ST-HL-AE-1399

South Texas Project  
Units 1 and 2  
Docket Nos. STN 50-498, STN 50-499  
Responses to DSER/FSAR Items; Section 2.5

The attachments enclosed provide STP's response to Draft Safety Evaluation Report (DSER) or Final Safety Analysis Report (FSAR) items.

The attachments include mark-ups of FSAR pages which will be incorporated in a future FSAR amendment unless otherwise noted below.

Figure 2.5.1-1

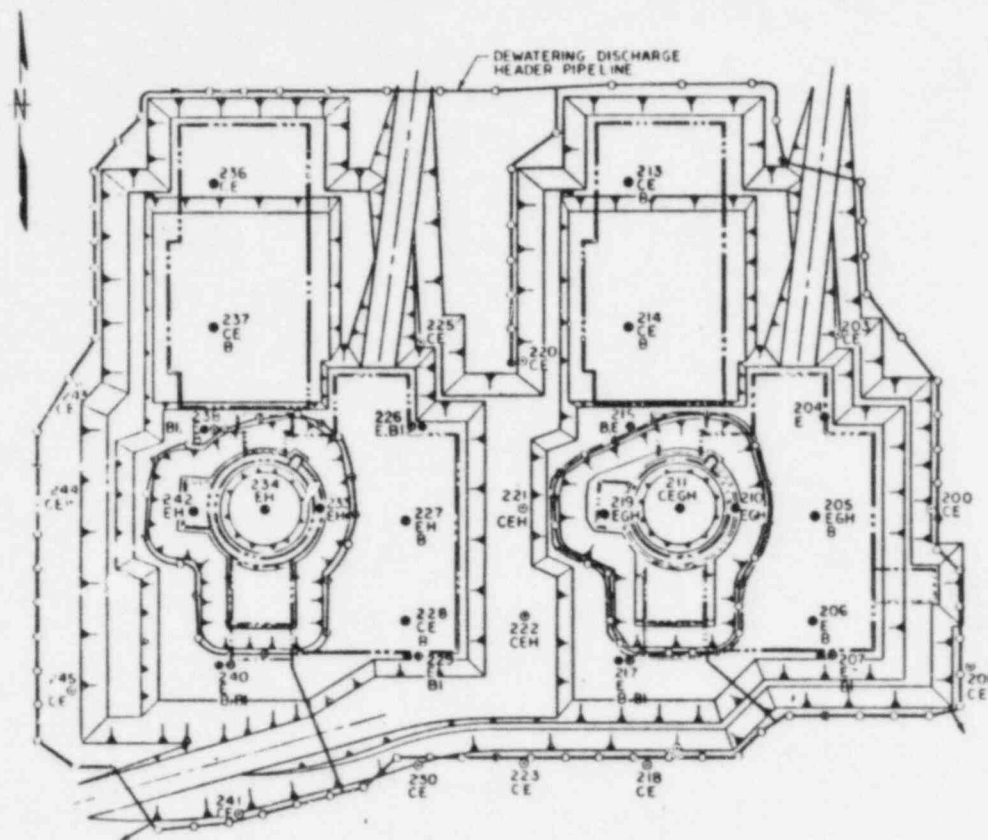
2.2.3.1.5 Gas and Oil Production Fields: <sup>identified</sup> The gas and oil production fields within 5 miles of the STP site are ~~described~~ in Section 2.2.2 and ~~their location is shown on Figure 2.2-3 and Figure 2.5.1-1.~~ The closest well to the STP site is a single well in the South Duncan Slough gas field, approximately 1.6 miles from the nearest STP safety-related structure.

Figure 2.5.4 - 70B

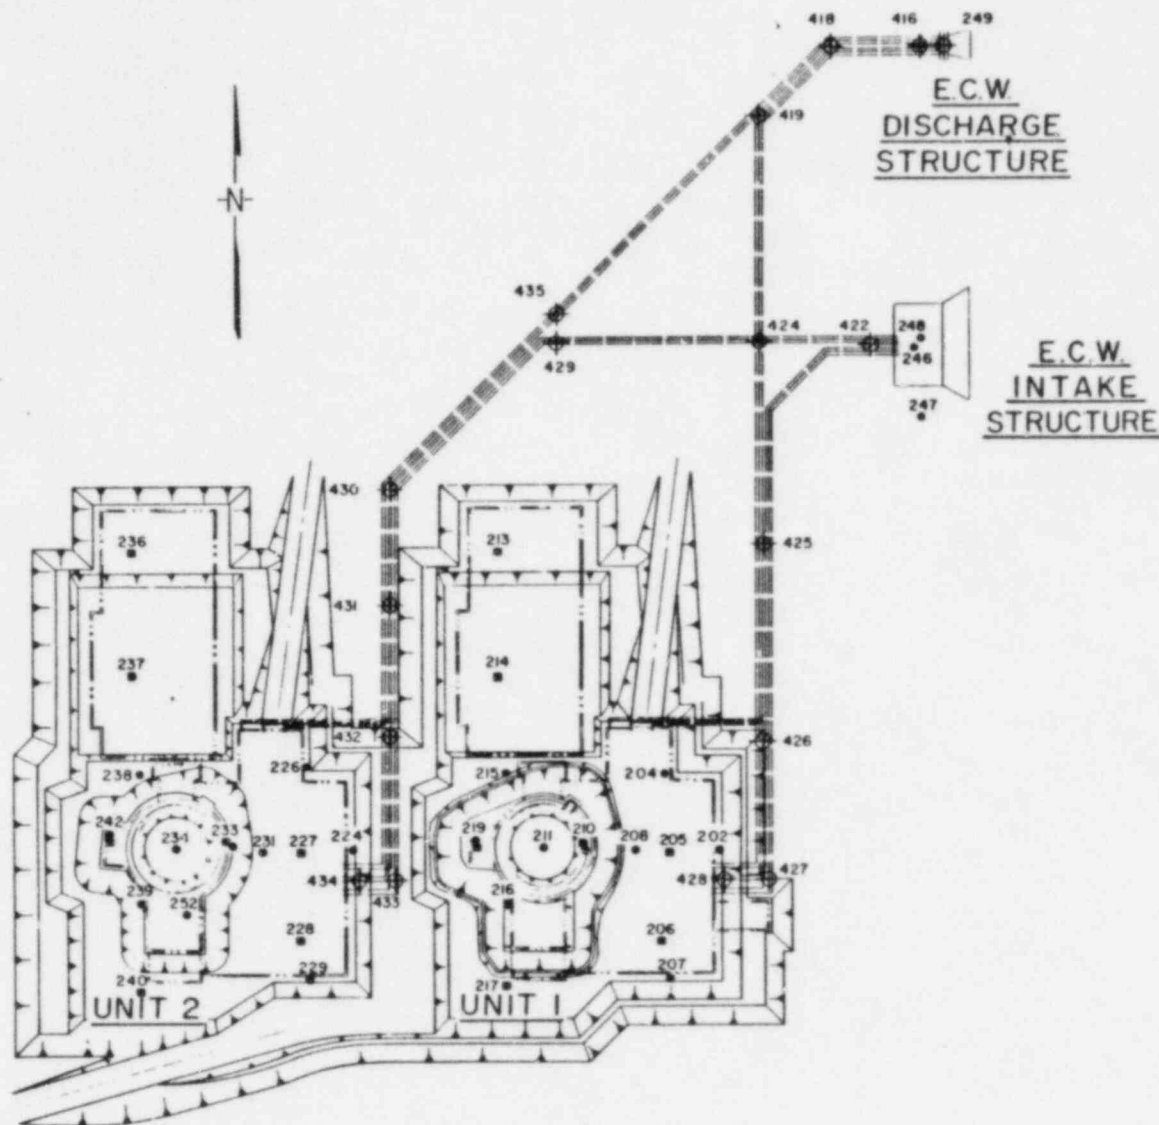
Historical piezometric levels in the site vicinity show the progressive lowering of the piezometric elevation of the deep aquifer zone (see PSAR Figure 2.4.13-5A). Prior to significant groundwater withdrawals, which began in the 1940's, deep aquifer-zone piezometric levels were slightly above ground surface. In recent history, the piezometric elevations have remained at about sea level from 1967 to 1973 near the eastern boundary but have declined from about El. -14 ft MSL to about El. -28 ft MSL at the western site boundary. For the STP plant site area, the 1975 piezometric level was estimated to be at El. -33 ft MSL (see PSAR Figure 2.5.1-16D). ~~in 1984 this level is at about El. -43 ft MSL (see Figure 2.5.4-70B).~~ AND FOR 1984 AND 1985 EL -43 FT MSL

AND -42 FT MSL, RESPECTIVELY (see Figure 2.5.4-70B).  
The groundwater elevations in the deep aquifer zone are conservatively estimated to be lowered an additional 87 ft below the observed elevations described above, in the period between 1973 and 2020 (see Section 2.5.1.2).

Figure 2.5.C-9

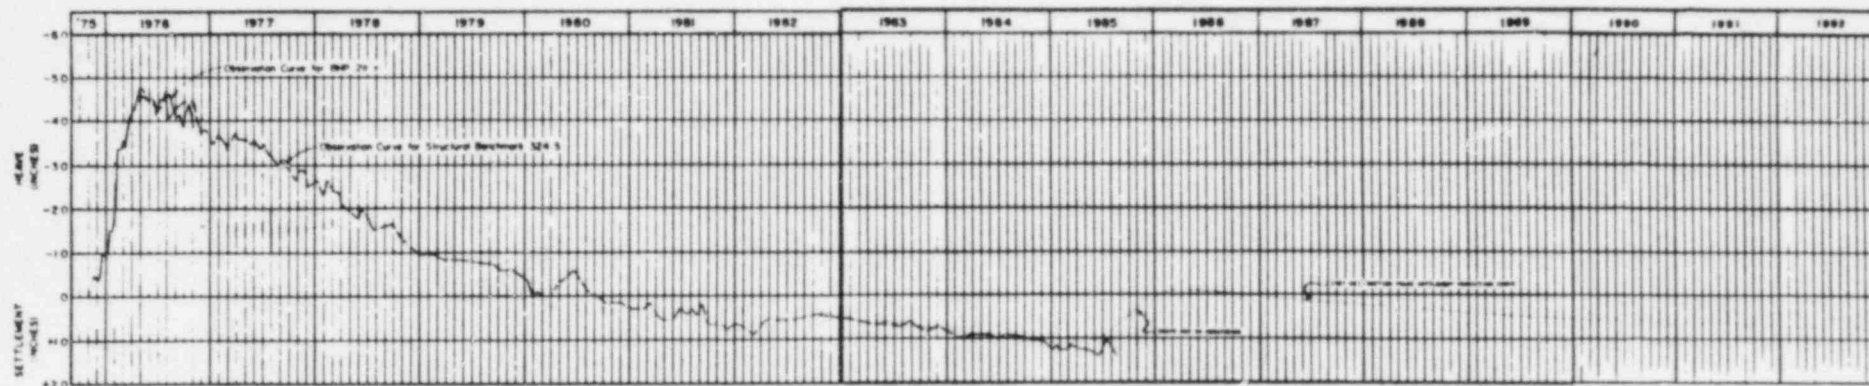
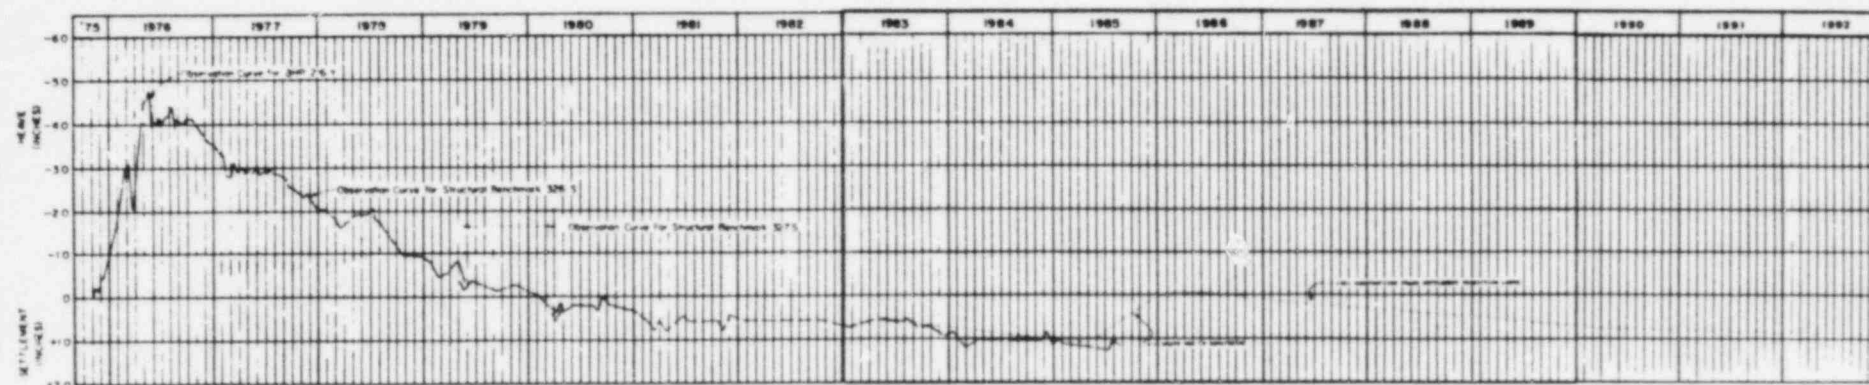
2.5.C.4.5.1 Unit 1 Area: The actual movements for the Reactor Containment, Fuel Handling, Mechanical-Electrical Auxiliaries, and Diesel-Generator Buildings are shown on Figures 2.5.C-9 and 2.5.C-9A. These curves have been taken directly from Sondex, BHP, and Structural Bench Mark observations at points near the foundation elevations for the buildings, as noted on the figure. The projected movement curves, based on the settlement analysis as described in Section 2.5.C.4.4.1 above, have been superimposed on the observed movement curves for each building. These projected movement curves are based on the settlement analysis for actual construction loads and instrument data to April 1983. ~~The projected movement curves show an agreement with the actual observed heave, recompression, and settlement.~~ *Insert X*

Figure 2.5.C-10

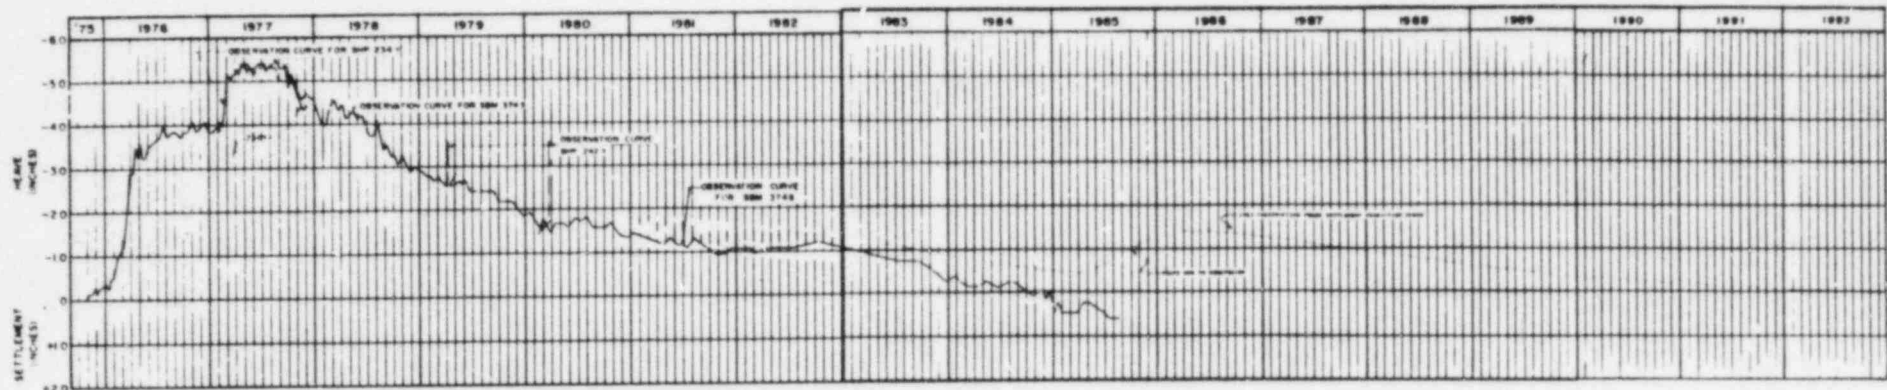
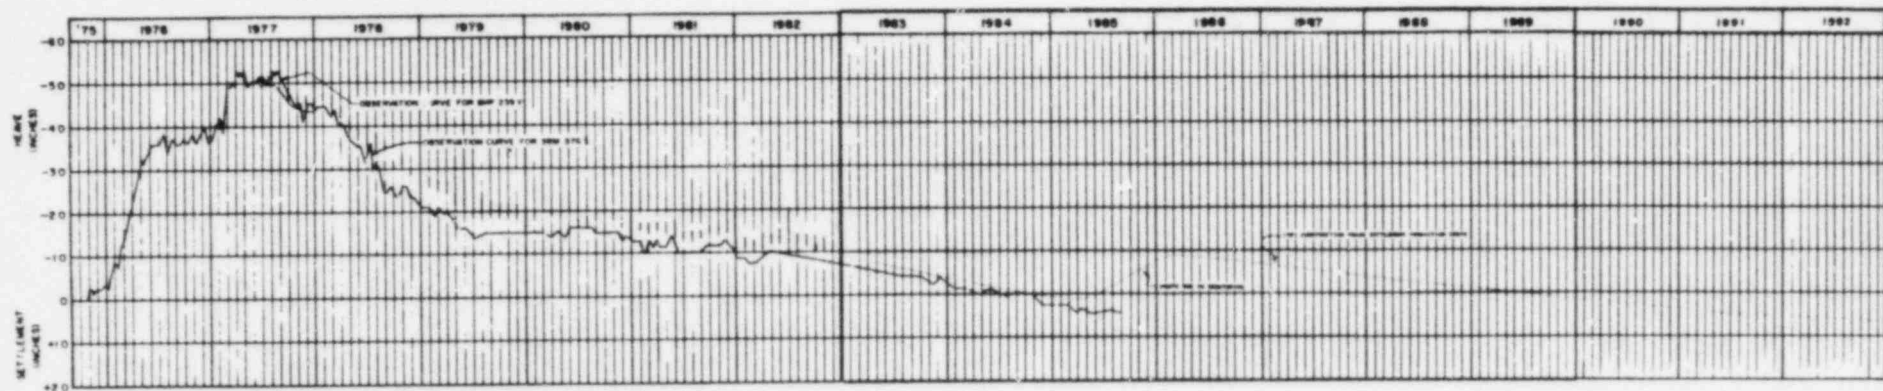
2.5.C.4.5.2 Unit 2 Area: The actual movements for the Reactor Containment, Fuel Handling, Mechanical-Electrical Auxiliaries, and Diesel-Generator Buildings are shown on Figures 2.5.C-10 and 2.5.C-10A. These curves have been obtained directly from Sondex, BHP, and Structural Bench Mark observations at points near the foundation elevations for the buildings as noted on the figure.

The projected movement curves are based on the settlement analysis as described in Section 2.5.C.4.4.1, above, have been superimposed on the observed movement curves for each building. The projected movement curves are based on the settlement analysis for actual construction loads and instrument data to May 1983 and the anticipated Unit 2 construction loads and schedule. ~~The projected movement curves show an agreement with the actual observed heave, recompression and settlement.~~

Figure 2.5.C-12A

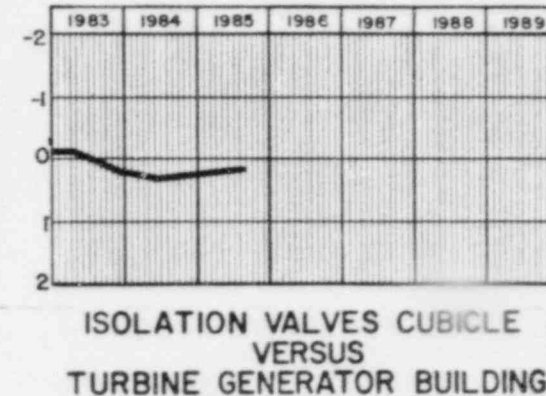
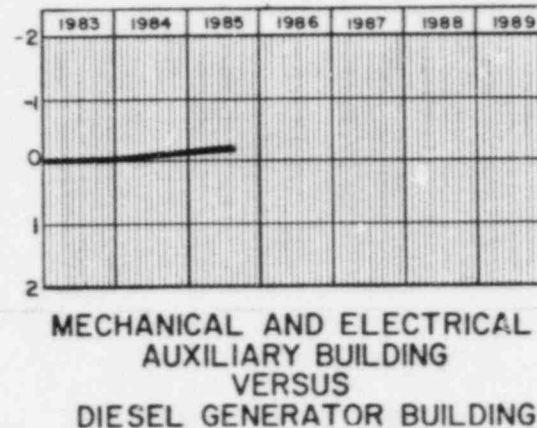
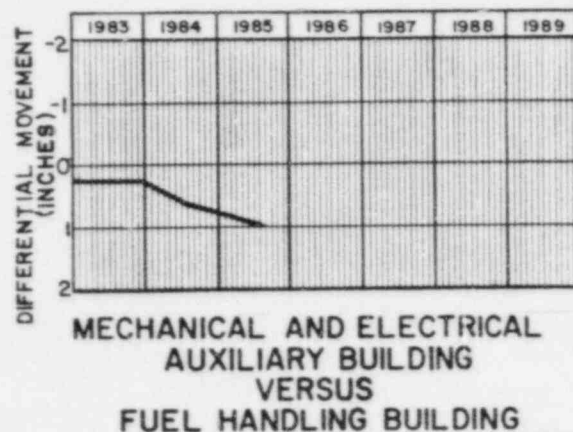
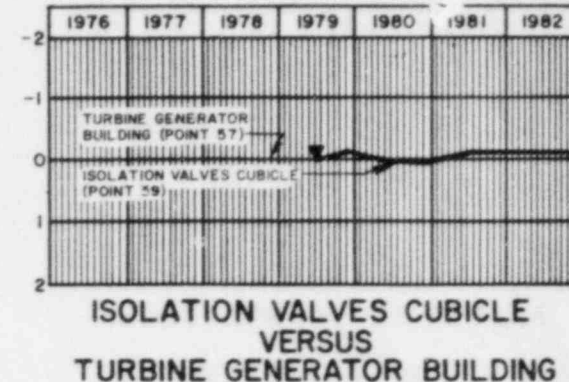
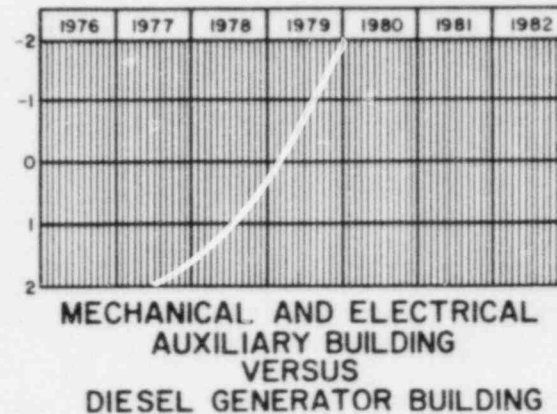
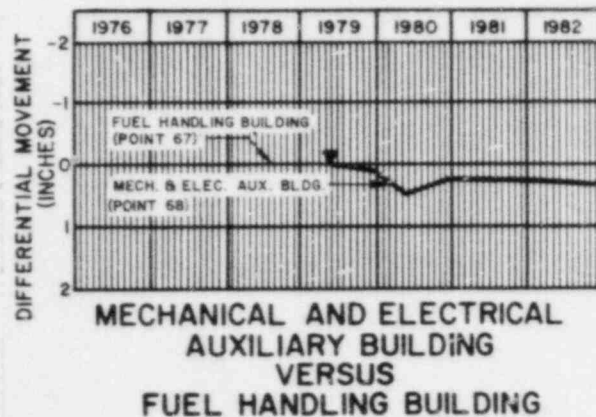
*Insert ①*  
The projected maximum differential settlement between locations (see Figure 2.5.C-3) are shown on Table 2.5.C-6. The projected tilt within the various structures is shown on Table 2.5.C-7. The observed differential movements between buildings <sup>are</sup> shown on Figures 2.5.C-12. ~~The differential movement profiles within buildings (tilts) is shown on Figures 2.5.C-14y and 2.5.C-12A.~~ *are (and 2.5.C-14A).*
